**COMMENTS ON THE
GRPE DRAFT ECE COMPRESSED GASEOUS HYDROGEN (CGH₂) REGULATION
Version 10 Dated 06.11.02
(NON GRPE/ISO HARMONIZATION)**

GRPE - 002

2003-01-06

Figure X: Flex-impulse testing fixture

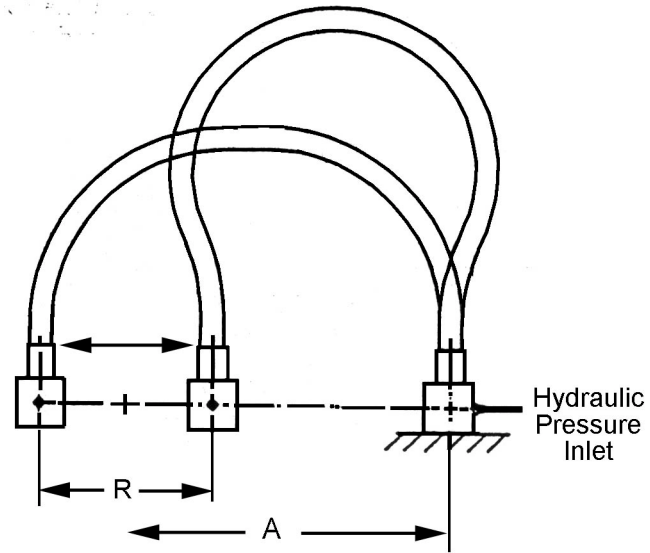
Paragraph/ Annex	Organisation	Comments/Proposed Modification	Agreed	Final Modification Or Reason For Rejection
6.1.8	DC	Add Container or Container Assembly		
10	RA	Change a part of the 1 st sentence from “for a type of component type approved” to “for a component that is type approved”.		
14.1.17	VTEC	Conflict between PRV activation pressure in 14.1.17 & Ann.8: B5.2.6		
14.2.3	DC	What are safety related parts? This wording is not known within the automotive industrie. Nevertheles this is wrong, the parts may be damaged, but their function has to be maintained.		
14.10.5	DC	Delete the last 2 sentences. If there is no leakage permitted they make no sense.		
18	RA	Change from “manufacture a type of Vehicle Type approved” to “manufacture a Vehicle Type that is type approved”.		
Annex 8, B5.2.3	EIHP2/Powertech	Replace the existing text with the proposal at the end of this document

Replace B5.2.3 with a combined flex-impulse test adapted from SAE J1405.

B5.2.3 Flexible Fuel Lines

The length of the flexible part of the *Flexible Fuel Line* with its fittings attached, to be used in the following test shall be calculated as follows:

$$L = 4.142R + 3.57D$$

- L = Length of the flexible part of the *Flexible Fuel Line*
- R = Minimum bending radius specified by the *Manufacturer*
- D = Outside diameter of the *Flexible Fuel Line*

The *Flexible Fuel Line* shall be bent in the manner depicted in Figure X and attached to a fixture in that position by the *Fittings* with which it is to be approved. One end of the *Flexible Fuel Line* shall be attached to a reciprocating manifold and the other end shall be attached to a stationary manifold connected to a hydraulic supply. The *Flexible Fuel Line* shall be pressurised quickly by means of a quick opening solenoid valve, such that one cycle consists of holding the pressure at 1.25 times the *Working Pressure* for 10 ± 1 seconds (except for *Flexible Fuel Lines* with a required material temperature of 120°C where the hold pressure shall be 1.37 times *Working Pressure*) and then reducing it to less than 0.1 times the *Working Pressure* for 5 ± 0.5 seconds. The total number of test cycles shall be equal to 2.0 times the number of *Filling Cycles* or *Duty Cycles* as appropriate to the use of the *Flexible Fuel Line* in accordance with Paragraph 2.4.6 or 2.4.7 of this Regulation as appropriate. 50% of the test cycles shall be performed at the minimum and the remaining 50% at the maximum material temperature in accordance with Paragraph 2.4.5.1 of this Regulation.

Superimposed on the hydraulic pressure cycles is a flexing cycle. The flexing rate shall be $36 \pm 2\%$ of the hydraulic pressure cycling rate. This assures that the *Flexible Fuel Line* is in a different configuration on each succeeding pressure cycle impulse. The test fixture is shown in Figure X with the distance A calculated as:

$$A = 1.75R + D$$

The *Flexible Fuel Line* shall not show any visible signs of damage.
